Access Compliance Report

Public Rights-of-Way

Intersection ID: 42506	Main Street: CHASEWATER_DR	Cross Street: DARBY_CHASE_DR	Location: SE
ADA ID: B68921907A69	Ramp Type: BlendTrans1	Initial Pass/Fail: Fail	Overall Compliance: No
			Severity Score: 33.75

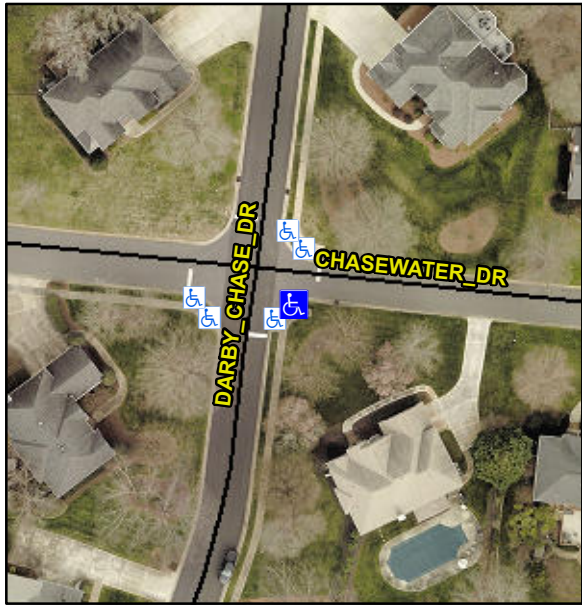
Codes/Mitigation Info/Possible Solution			Field Measurements/Component Compliance					
	Possible Solutions:		Compliance	Description	Data	Compliance	Description	Data
	Remove & Replace Curb Ramp With Two New Directional Ramps or Equivalent.		N/A	Ramp Length (in)	49.0	Yes	BlendTrans Slope (%)	3.5
			No	Ramp Width (in)	46.0	No	BlendTrans XSlope (%)	7.2
			N/A	Flare Type LT	N/A	N/A	Flare Type RT	N/A
			N/A	Flare Slope LT (%)	N/A	N/A	Flare Slope RT (%)	N/A
			N/A	Flare Traversable LT?	N/A	N/A	Flare Traversable RT?	N/A
			N/A	Landing Length (in)	N/A	N/A	DWS Provided?	N/A
			N/A	Landing Width (in)	N/A	N/A	DWS Contrast?	N/A
			N/A	Landing Slope (%)	N/A	N/A	DWS Length (in)	N/A
			N/A	Landing X Slope (%)	N/A	N/A	DWS Full Width?	N/A
Surveyor Notes:	N/A		N/A	Landing Curb? (Y/N)	N/A	N/A	DWS Offset (in)	N/A
			N/A	Shared Landing?	N/A			
	PROW/ADA:		N/A	Gutter Ponding?	N/A	N/A	Gutter Slope (%)	N/A
	Not Found, R304.5.1, R304.5.3		N/A	Gutter Lip Ht (in)	1.0	N/A	Gutter X Slope (%)	N/A

N/A	Painted X Walk1?	No	N/A	Painted X Walk2?	N/A
				X Walk 1 Direction	To N		X Walk 2 Direction	N/A
				X Walk 1 Width (in)	N/A		X Walk 2 Width (in)	N/A
				X Walk 1 Slope (%)	3.2		X Walk 2 Slope (%)	N/A
				X Walk 1 X Slope (%)	0.6		X Walk 2 X Slope (%)	N/A
			N/A	Ramp inside XWalk1?	N/A	N/A	Ramp inside XWalk2?	N/A
			Road Slope (%)	0.6		Clear Space?	N/A	
			Road X Slope (%)	3.2	N/A	Clear Space to XWalk (in)	N/A	
		N/A	Any Obstructions?	N/A	N/A	Storm Grate/Utility Hazard?	N/A	
			Obstruction Type			Storm Grate/Utility Type		
					N/A			N/A
					Yes	Surface Condition? (G/P)	Good	
					No	Curb Slope (%)	17.0	
Total Cost:		\$ 3200.00
